**Proof of Evidence relating to Flood Risk and  
Drainage Matters**

**Save Fulbourn Fields and Fulbourn Forum  
Rule 6 party**

**PINS Reference: APP/W0530/W/22/3291523**

**LPA Reference: S/3290/19/RM**

Figure 1: Drainage Strategy – 2014 Flood Risk Assessment (CDC12)

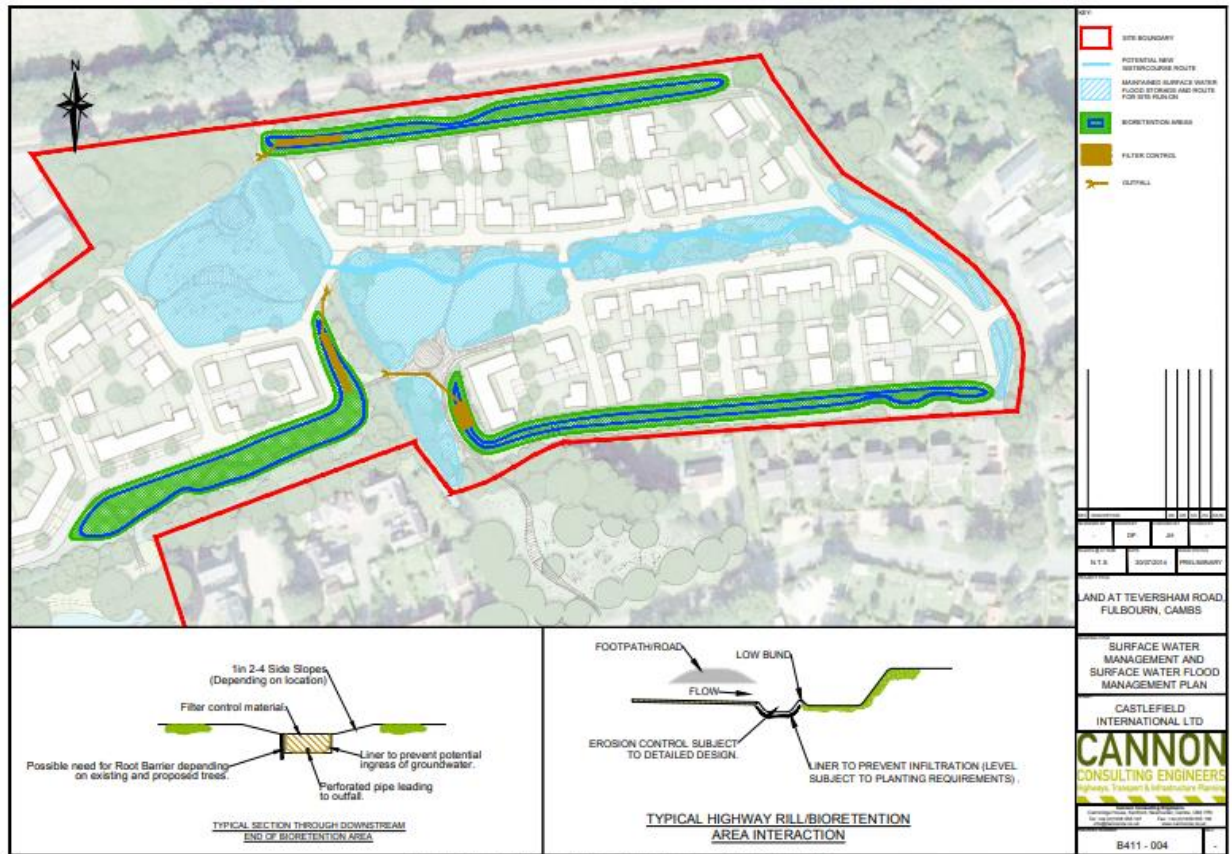
5.7 The scheme as presented also appears to conflict with Condition 8 as it is not based upon the original Flood Risk Assessment. The original Flood Risk Assessment included a strategy which comprised several shallow bio-retention areas/attenuation basins along with a new watercourse and clear flood storage areas. All proposed surface water drainage discharged to the central watercourse within the site. The scheme has evolved to remove the majority of the open attenuation areas in favour of underground solutions with only the northern basin remaining. No central watercourse is shown. A connection for part of the site is now proposed to the pump garden house pond. Discharge rates have also changed with the proposed discharge rate on the latest 2022 submissions significantly higher than originally proposed.

5.8 The changes between the design are shown in Figure 1 and 2 below and can be considered to be materially different.

DRAWING NUMBER	REV.
B411 - PL - SK - 304	P02

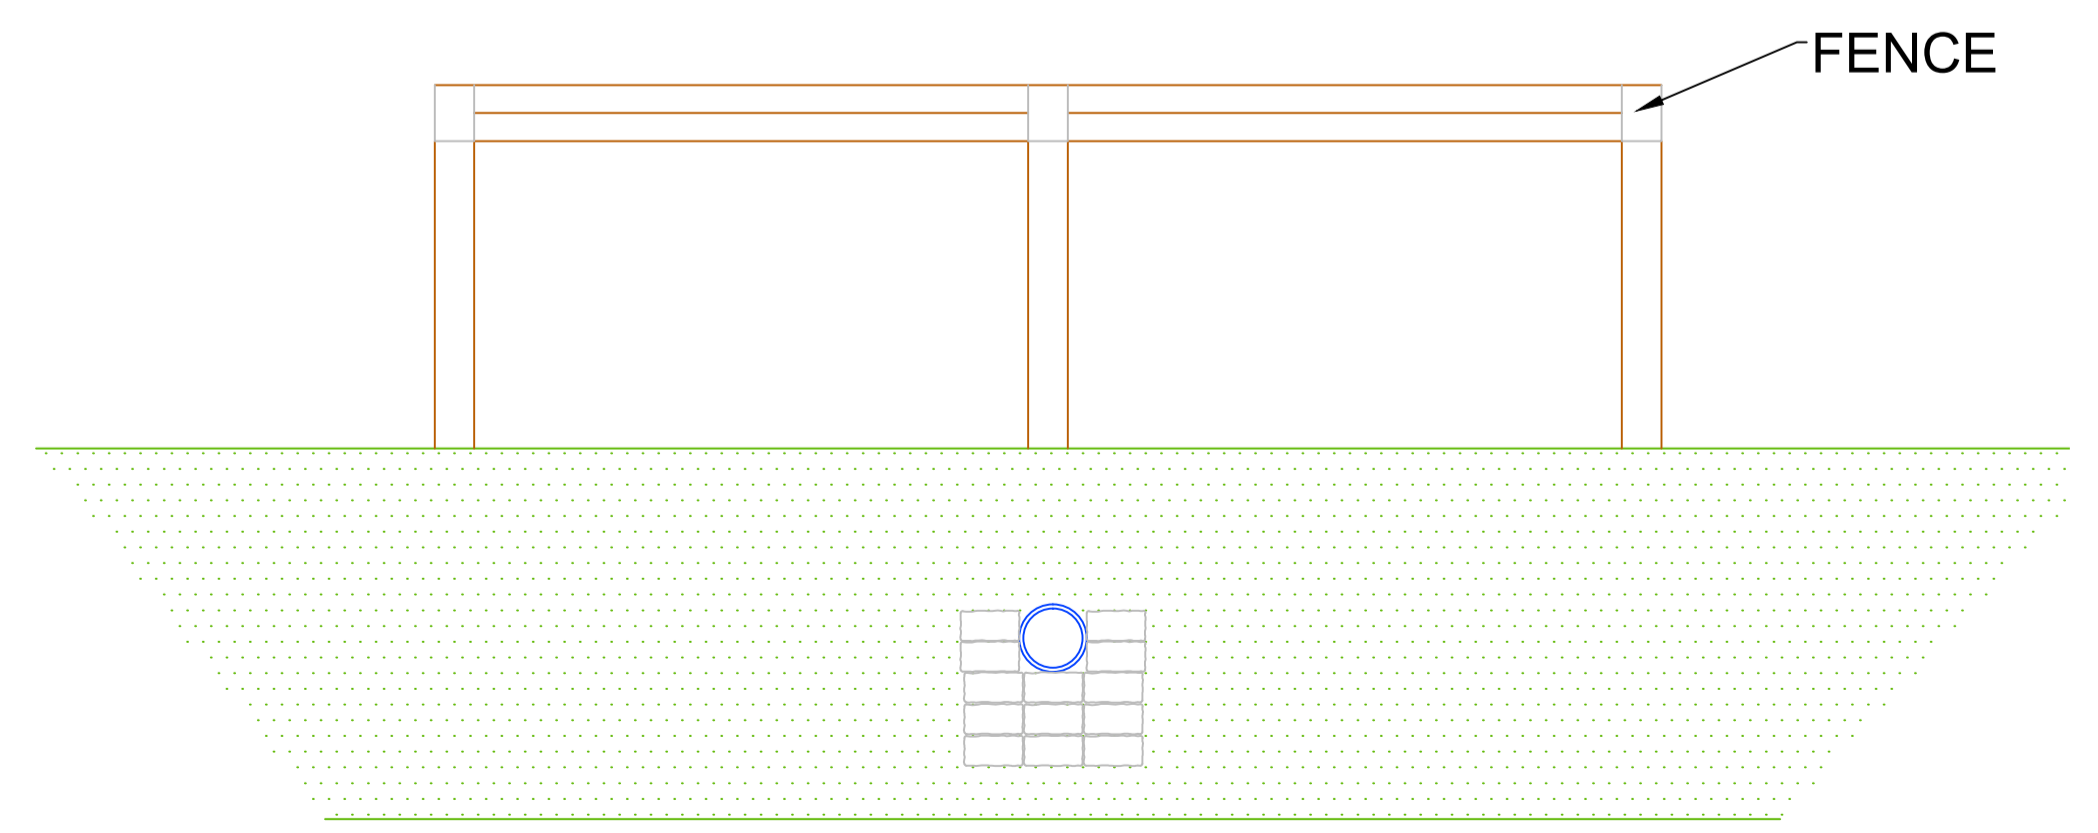
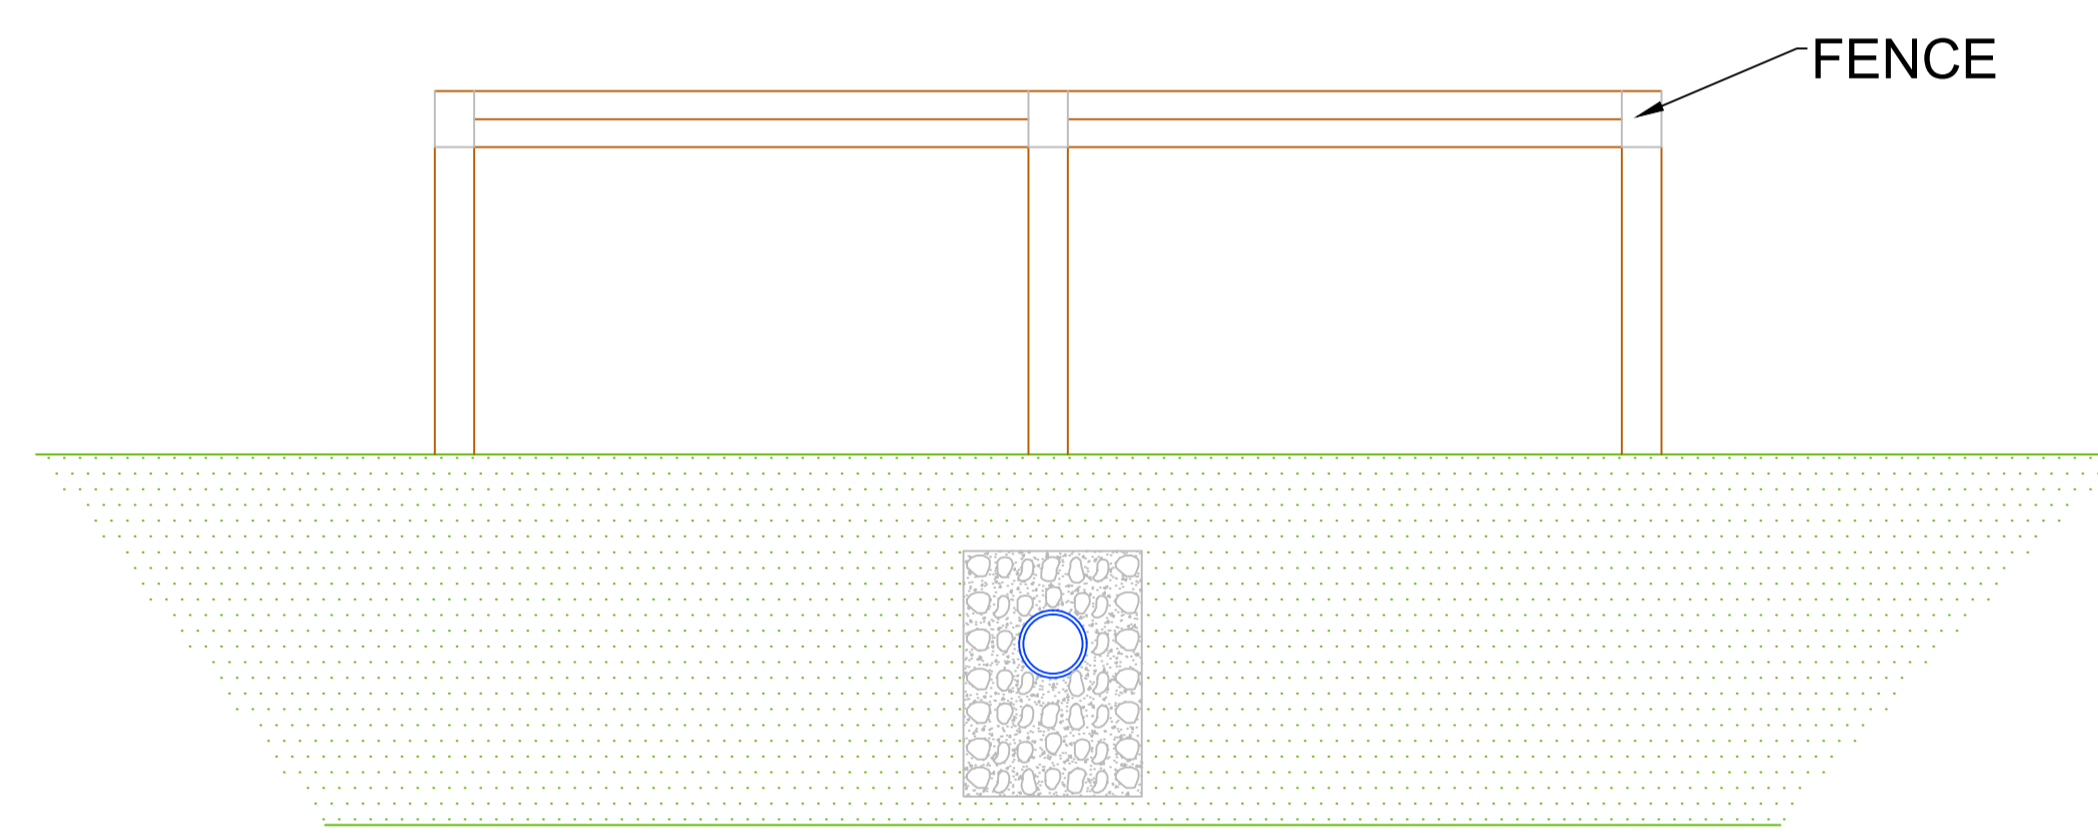
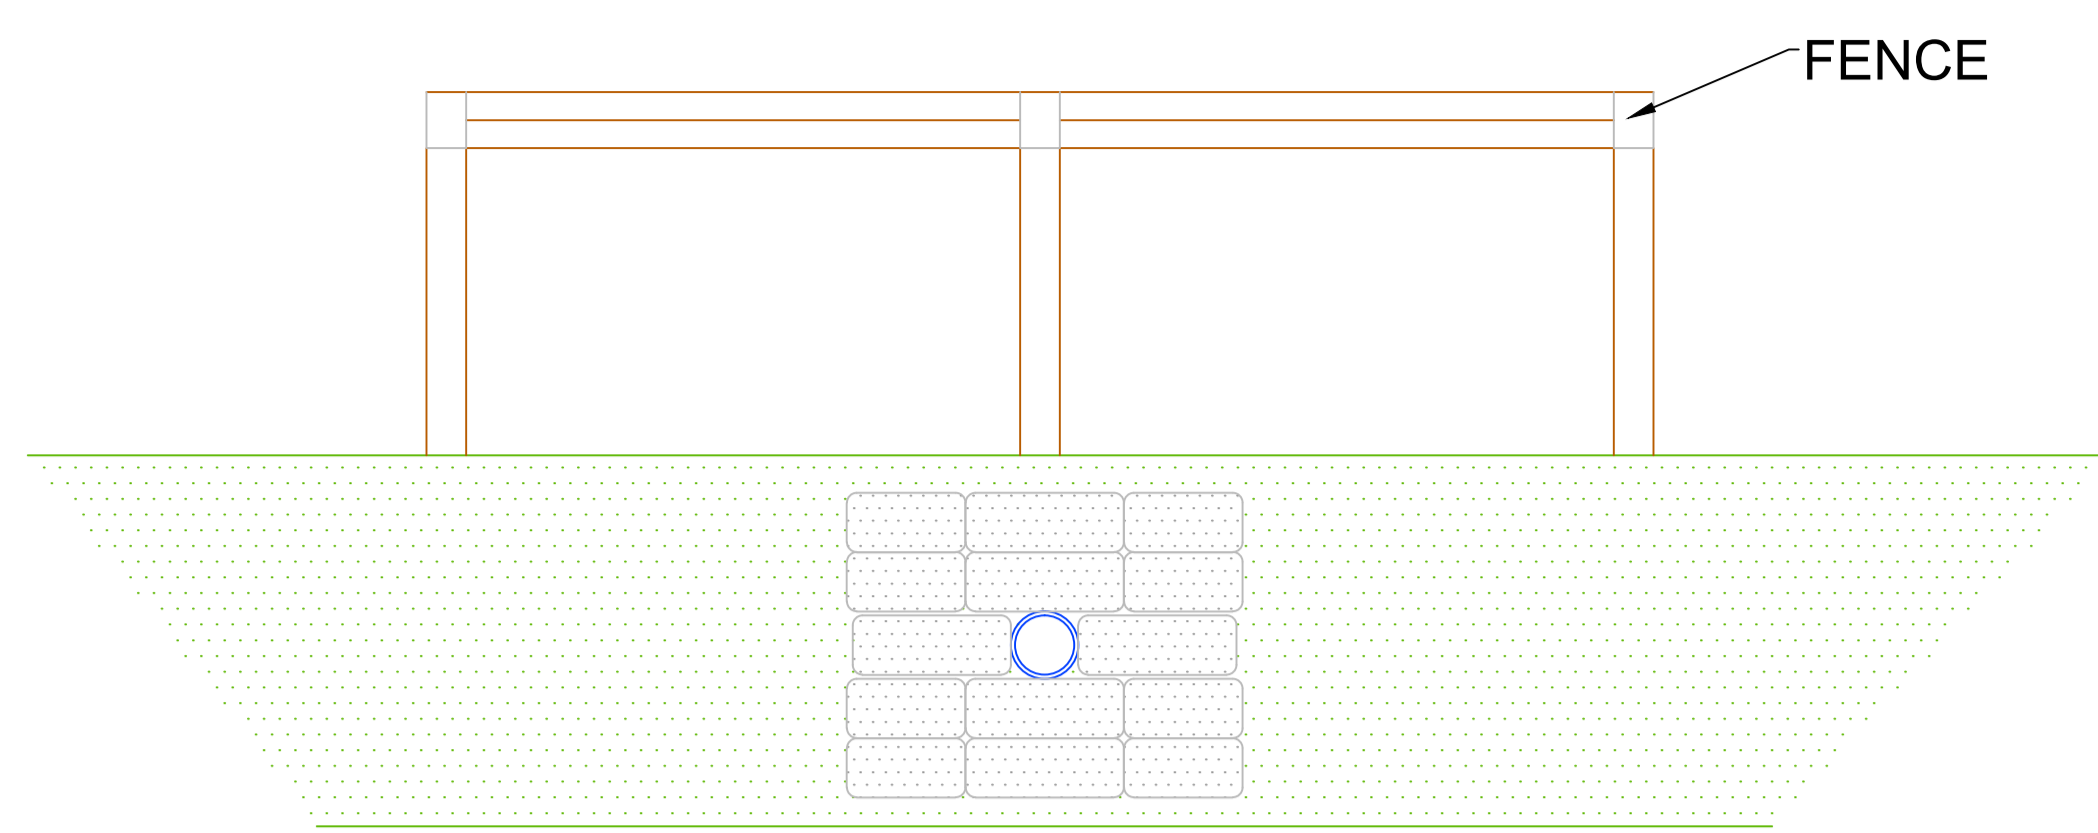
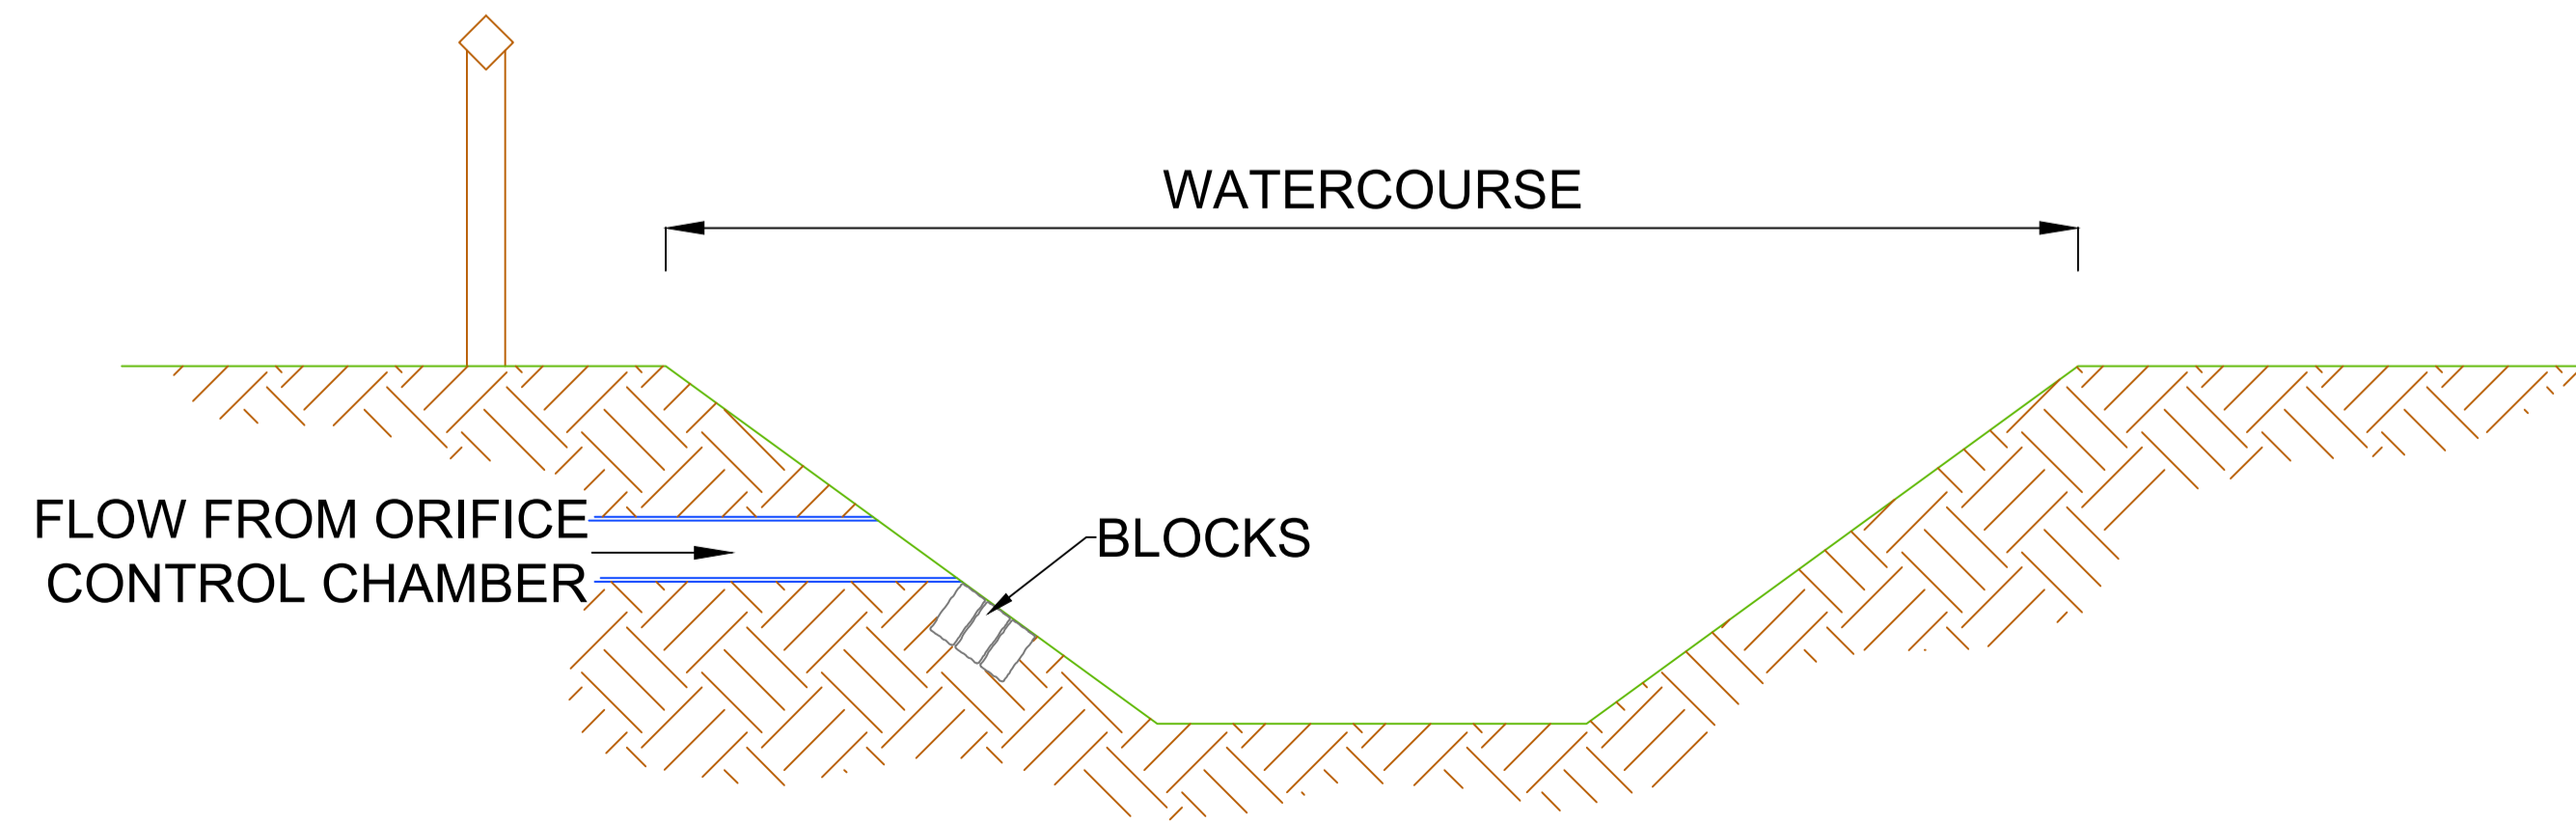
- Permeable paving is shown across the site. The construction details as presented in **Appendix 4** (see Cannon Consulting drawing B411-PL-SK-304 Rev P02) do not include any dimensions or

depths. In our experience a typical detail for permeable paving as proposed would have a depth of 0.79m as shown on the example in **Appendix 8**. Based on the recorded groundwater levels permeable paving would fail and would be subject to flooding unless all roads are raised which we assume will be the case, albeit limited road levels are provided and no updated levels are presented in the 2022 reports.

- The typical construction details as presented in **Appendix 4** show permeable paving discharging into a cellular storage tank which is wrapped in a geotextile to prevent groundwater ingress. The permeable paving is shown to discharge directly into the storage tank, however this cannot be achieved due to the presence of the geotextile which would prevent permeability. The same is also shown for the basin over crates. These details are flawed and would ultimately render the storage ineffective.
